PCM Service Update

Coast Guard Safety Recall

5.0/5.7L Ignition Coil Wire Replacement

**Engines Affected: 5.0L MPI (Pro Ski)
5.7L MPI (Excalibur)**

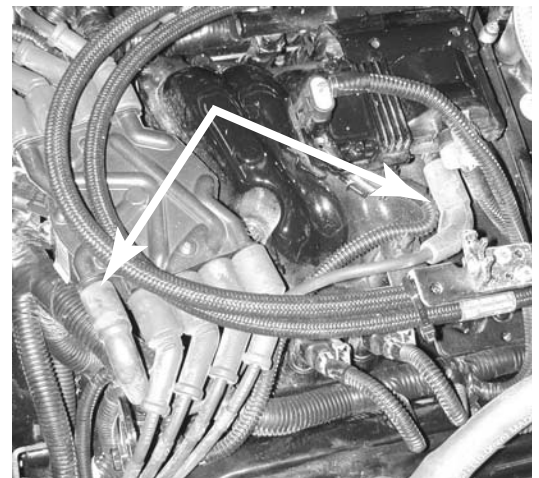
3. Remove the old ignition coil wire (BLACK) from the ignition coil and distributor cap.

IMPORTANT: THE BLACK IGNITION COIL WIRE MUST NOT BE REUSED. DISCARD THE BLACK IGNITION COIL WIRE.

4. Install the new ignition coil wire (RED) onto the ignition coil and distributor cap.

IMPORTANT: Make sure the ignition coil wire is pushed securely onto the towers of the ignition coil and the distributor cap. The wire will snap into the tower when properly installed.
